Proposal for amendments to UN Regulation No. 107

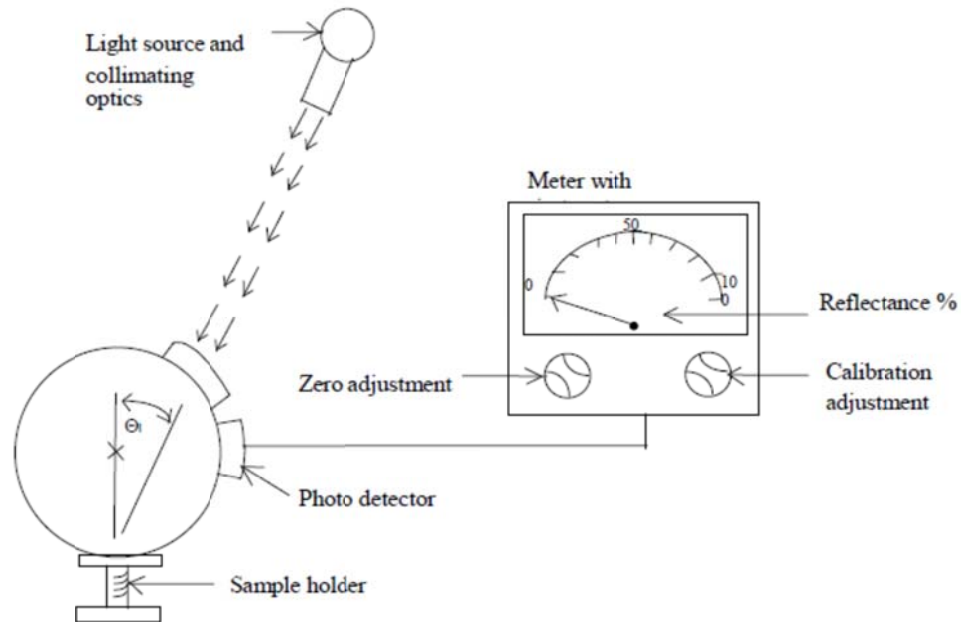
2. For determination of the reflectance values ρ_1 , ρ_2 and ρ_d an integrating sphere according to CIE 38:1977 shall be used.

The reflectance shall be either read directly from the indicating instrument or calculated according to the following formula:
